<b>Meeting:</b>	September	<b>Sublots:</b>	31
<b>Applicant:</b>	Spring Glen Development Co.	<b>Zoning:</b>	RR Controlled Density (CDZ) Overlay
<b>Engineer:</b>	Cunningham & Assoc.	<b>Utilities:</b>	Central water and sanitary sewer
<b>Site Area:</b>	44.4015 acres	<b>School Dist.:</b>	Buckeye Local
		<b>Reviewer:</b>	Rob Henwood

The site is located on the west side of Marks Road south of Sleepy Hollow Road (see location map). The applicant proposes to extend Middleton Place and construct Drayton Hall and Summerville Drive; the latter will terminate in a street stub to adjoining undeveloped property. The site will contain 31 sublot that are to be served by central water and sewer.

Staff recommends **APPROVAL WITH MODIFICATIONS**

**BENNETT LAKE FARM SUBDIVISION  
 PHASE 2  
 PROJECT NO. 05-213 SHEET 2 OF 4**

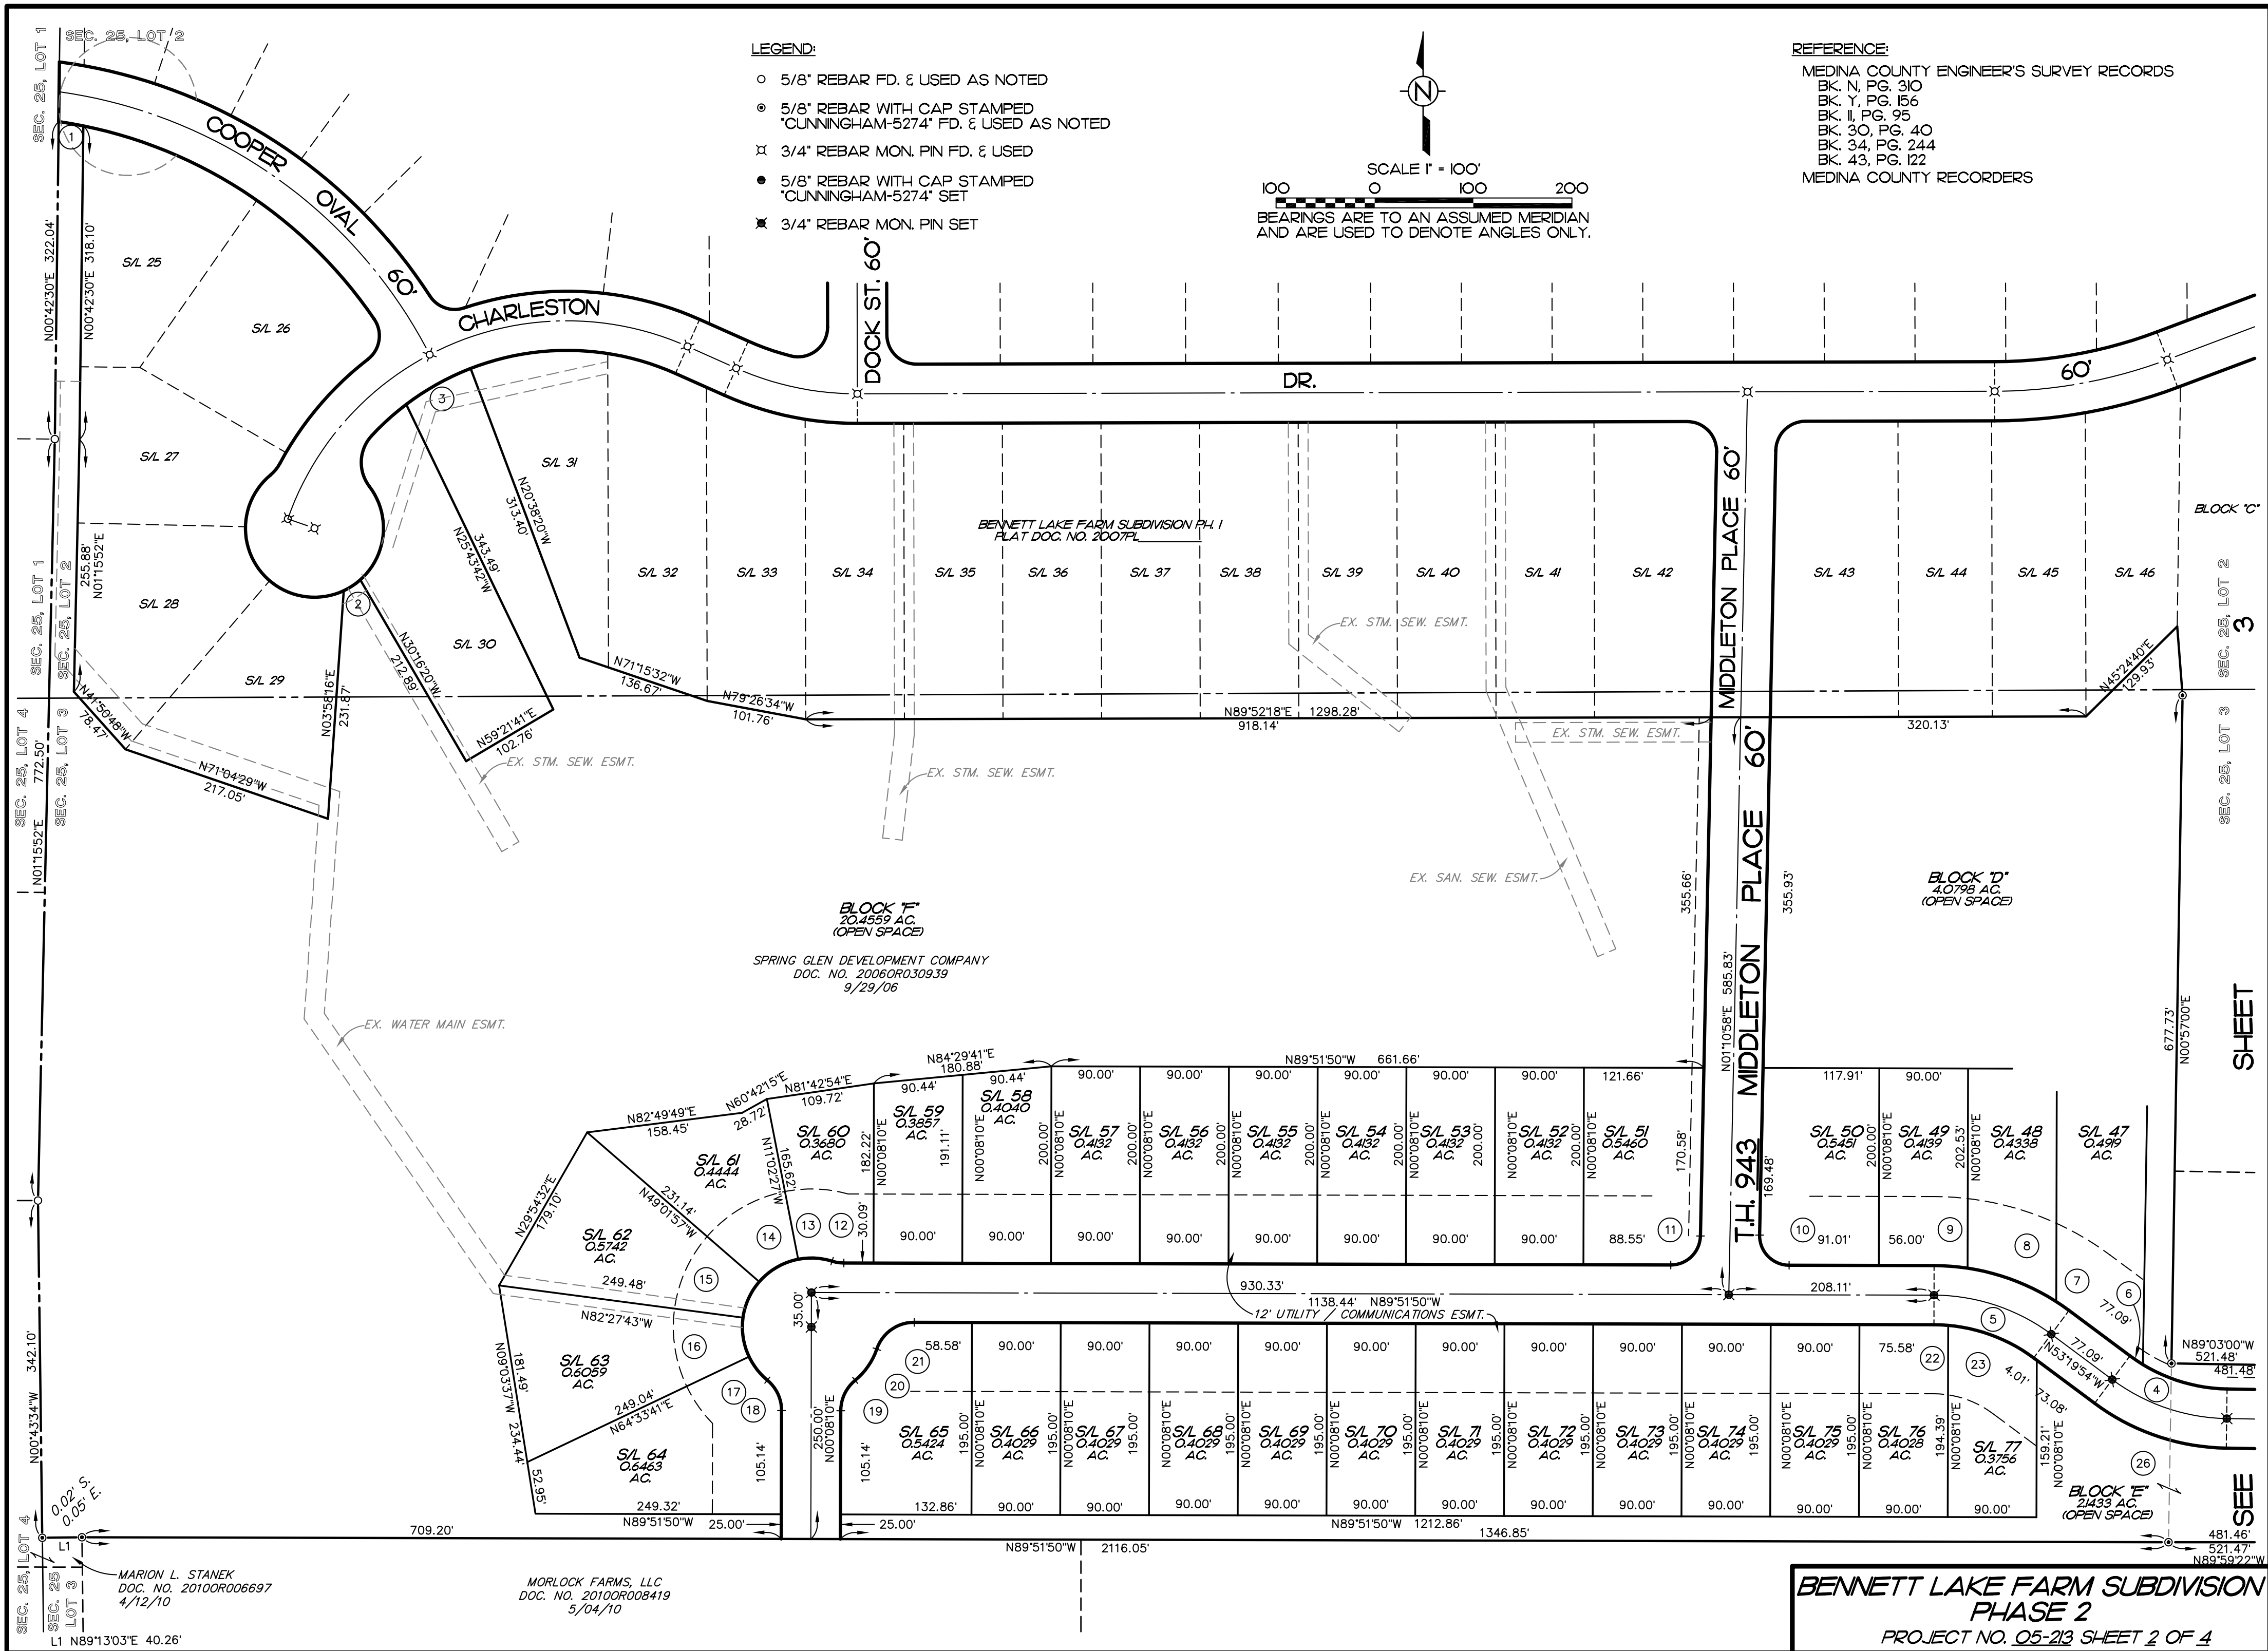
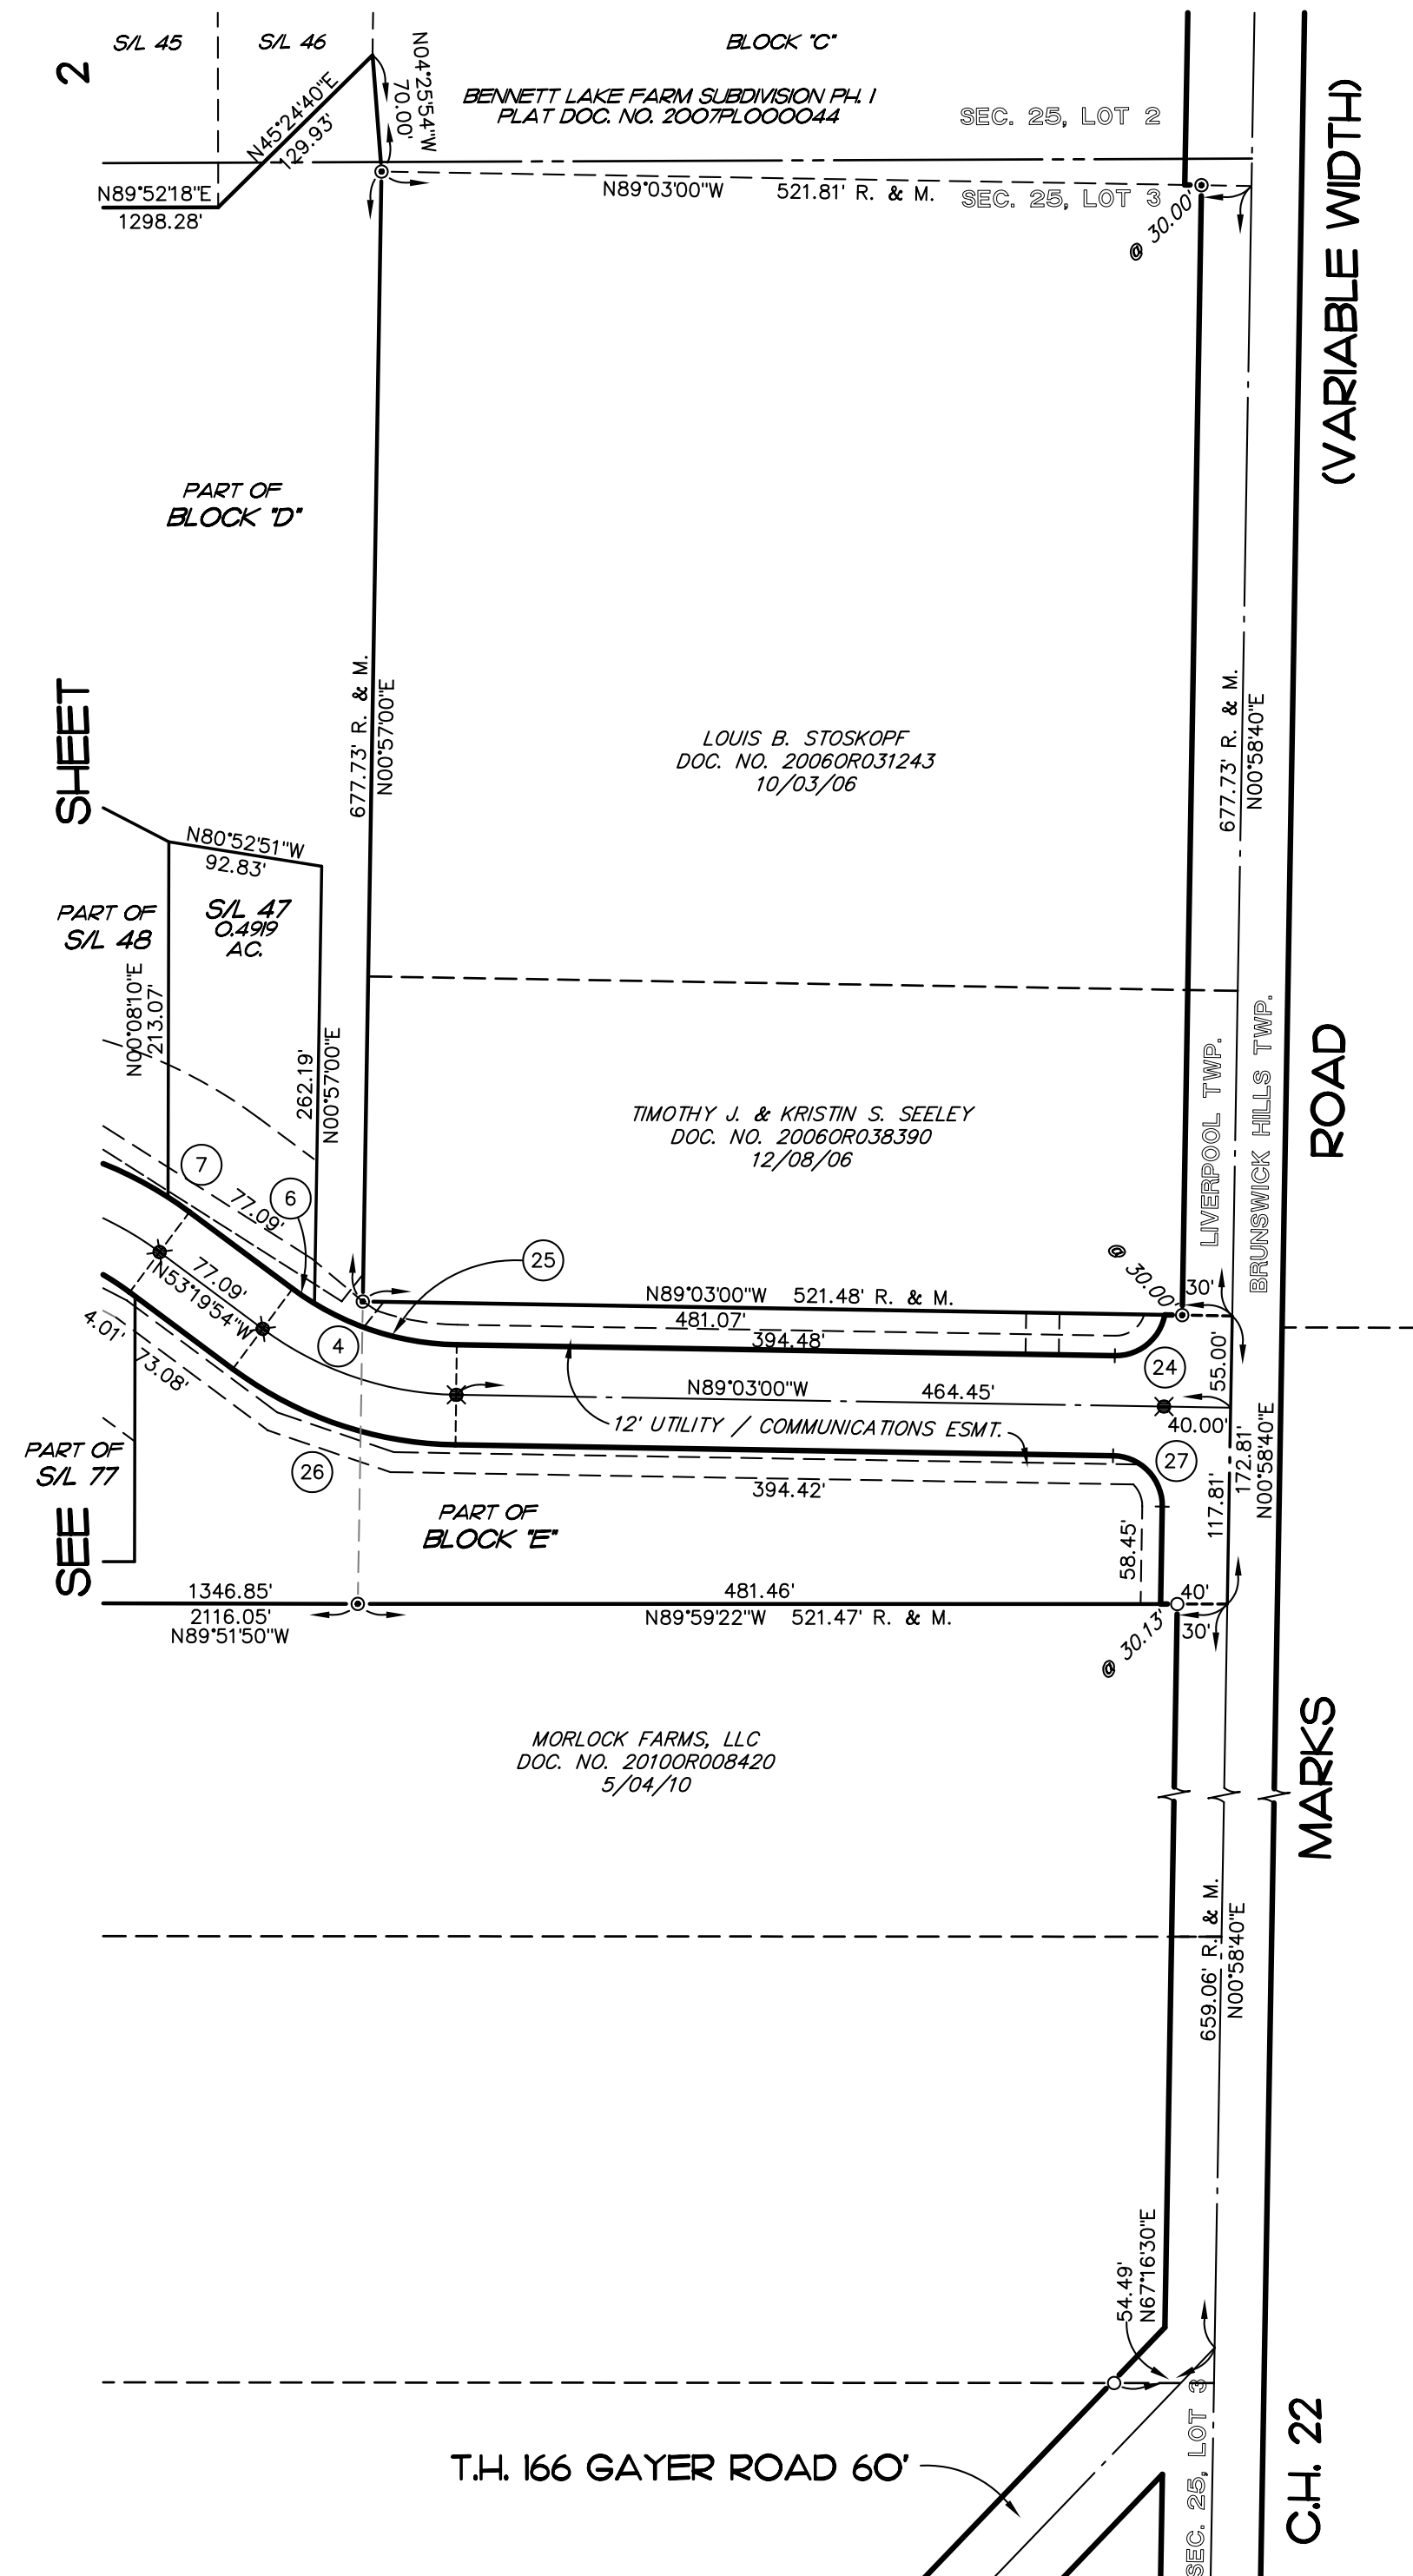
Show a temporary turn-around at the terminus of Summerville Drive consistent with the design requirements specified in the Engineering Code.

1. Satisfy the comments of the Highway Engineer as shown above.
2. Provide all missing data/information on or with three copies of a corrected Final Plat.
3. Reservation easements must be indicated on the plat as required.
4. Temporary turn-arounds must be reconfigured as required by the Highway Engineer.
